FIELD SAMPLING PLAN ADDENDUM 7

WEST LAKE LANDFILL SUPERFUND SITE OPERABLE UNIT 1

APRIL 15, 2022

Figure A7-1 Addendum 7 Proposed Sediment Sample Locations and Probing Transects

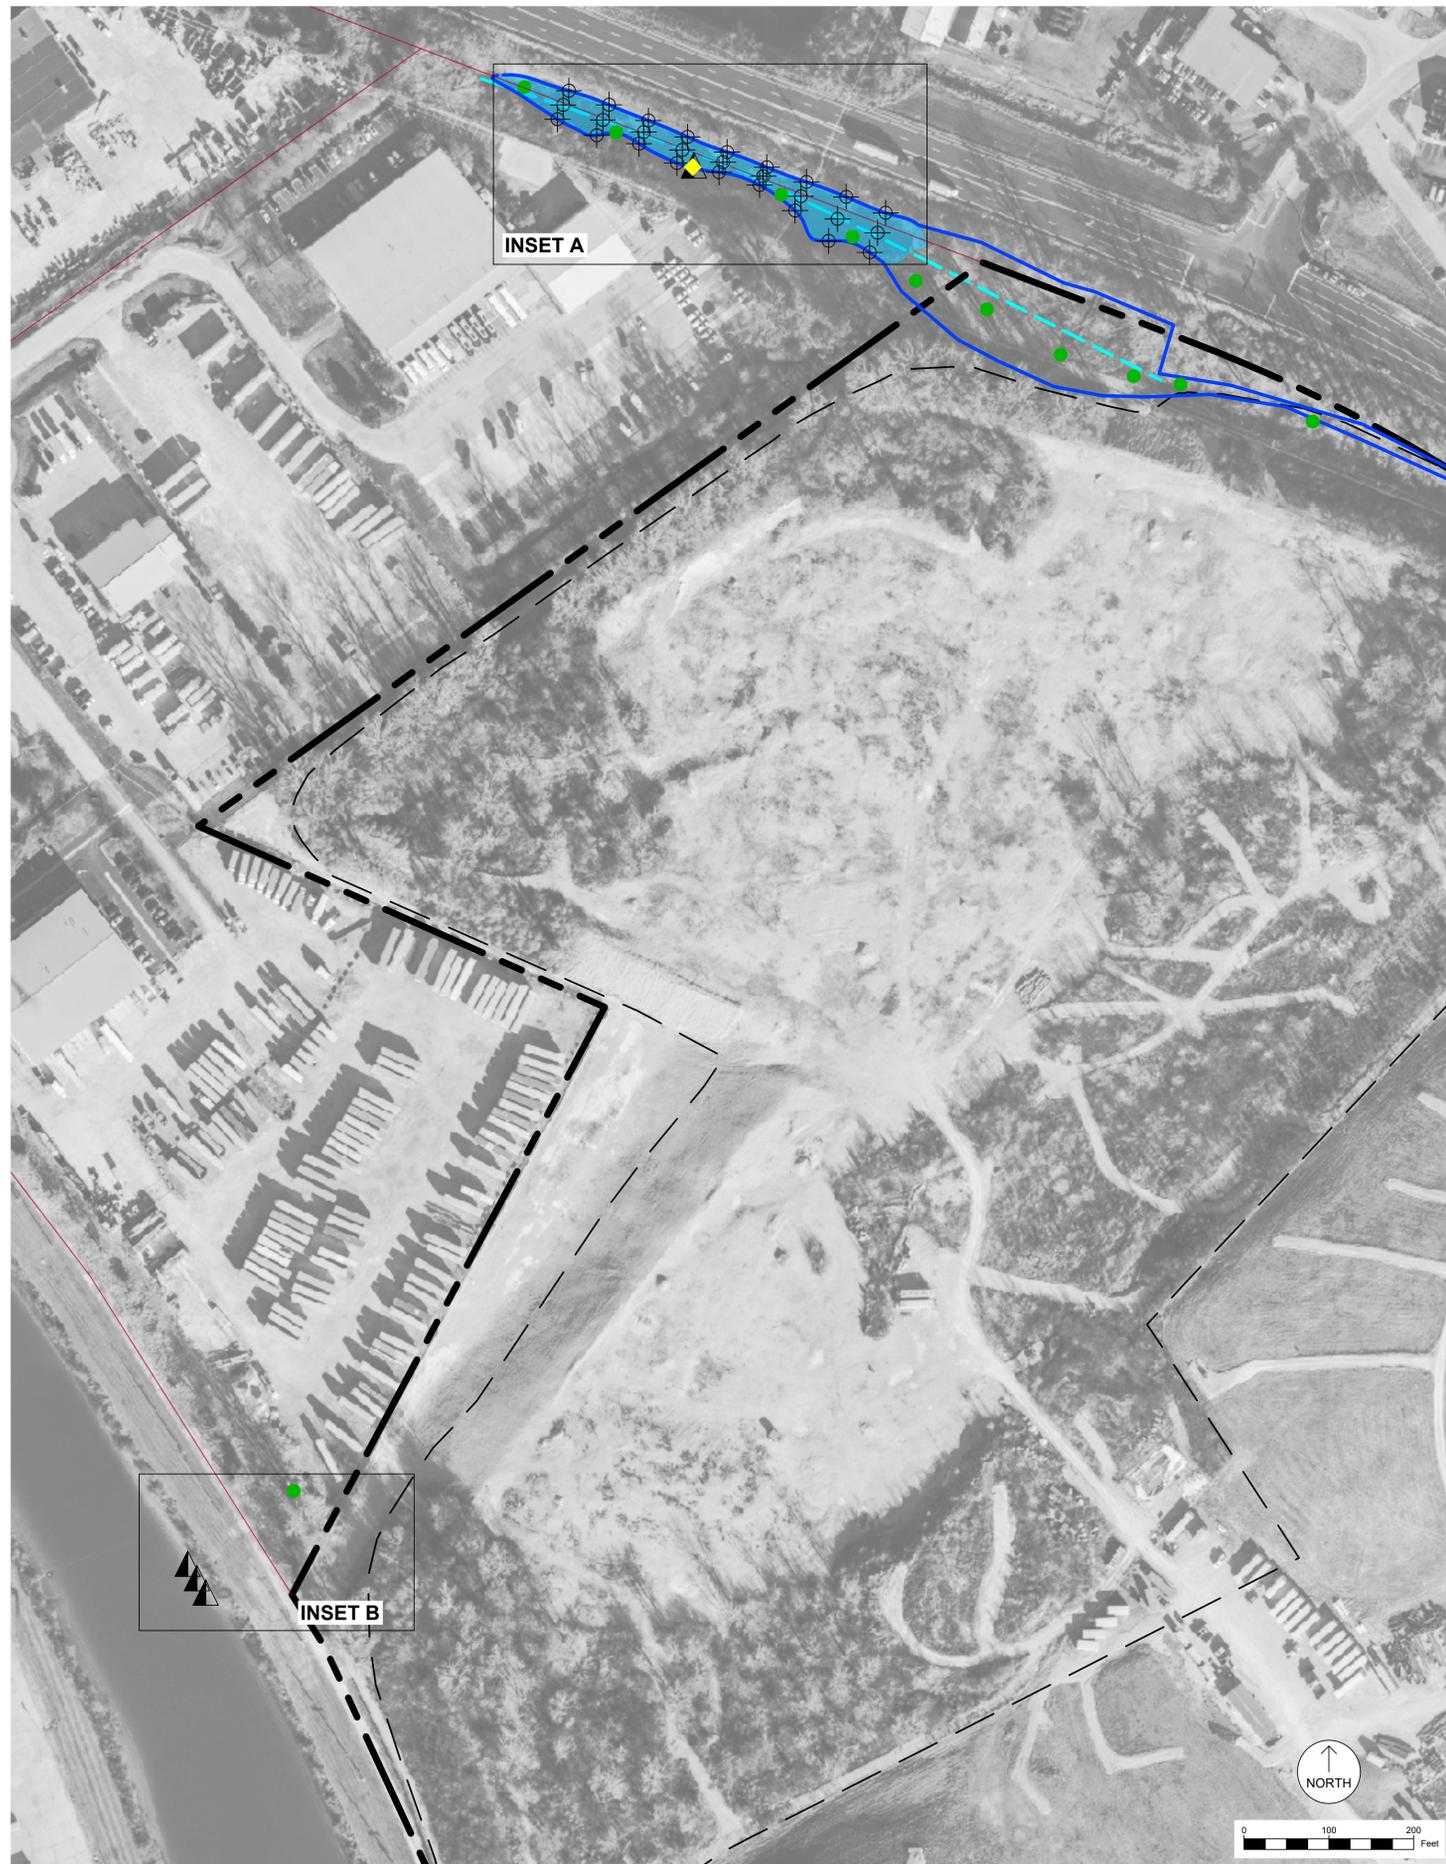
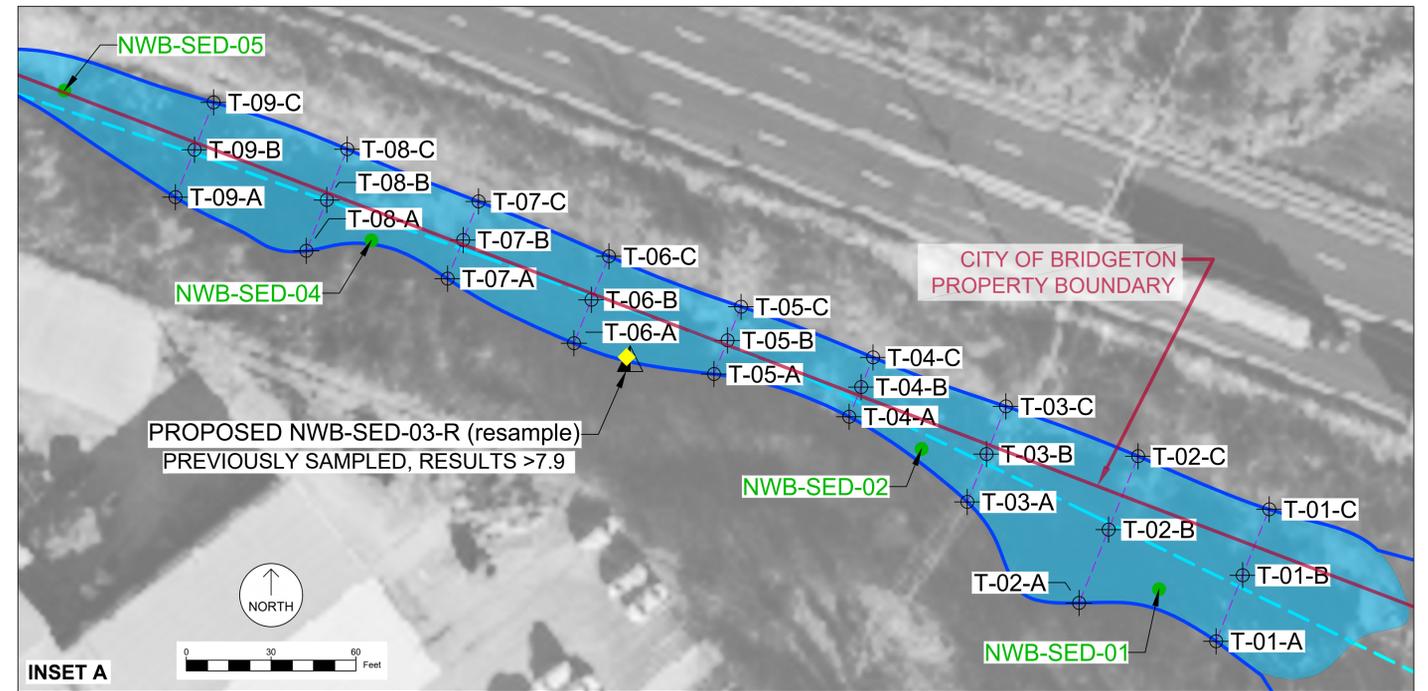
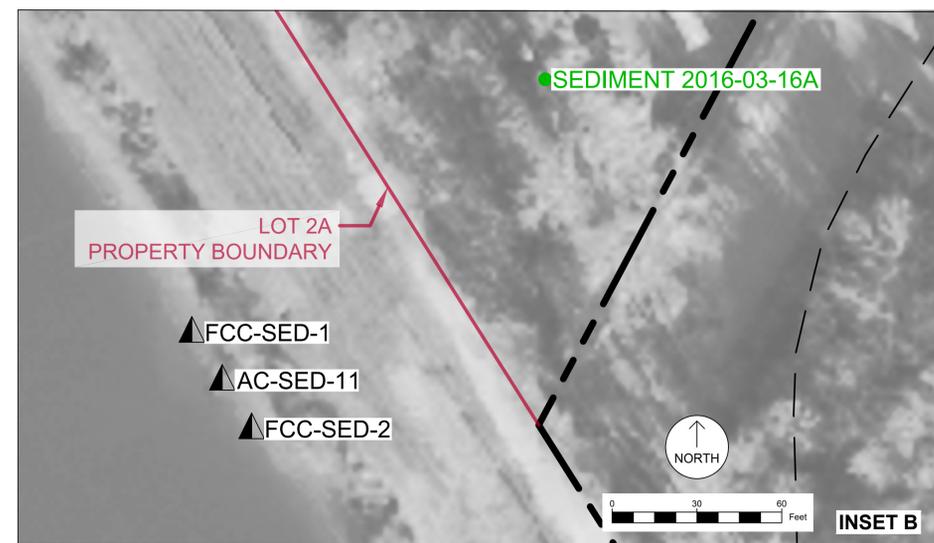
As requested by EPA in its April 4, 2022 letter, two additional samples will be collected in the area adjacent to the Earth City Flood Control Channel (Figure A7-1). One sample location has been added 15 feet to the north of AC-SED-11, and a second sample location has been added 15 feet to the south of AC-SED-11. These samples, as well as the previously planned sample at AC-SED-11, will be collected pending resolution of access agreements for the area.

In the April 4, 2022 letter, EPA also requested collection of an additional sample located 15 to 20 feet west of AC-SED-11, towards the center of the Earth City Flood Control Channel. The need for this sampling location will be evaluated following receipt and assessment of the analytical results of AC-SED-11 and the associated north and south samples mentioned previously. Collecting a sample from the center of the Earth City Flood Control Channel will require mobilization of specialized equipment due to the expected water depth and would entail different sampling methodologies than what are proposed in this Addendum and used previously at the Site.

Additionally, the procedures for sediment probing are also presented in Attachment 1. Sediment probing will be conducted at 12 transects, spaced approximately 50 feet apart. Each transect is generally composed of three probing locations: one probing location adjacent to each bank as well as a midpoint location. Transects located

In areas where the Northern Water Body is less than 20 feet in width, a singular representative location will be selected near the midpoint of the water body.

The details regarding the proposed sample and probing locations are summarized in Table A7-2 and shown in Figure A7-1.
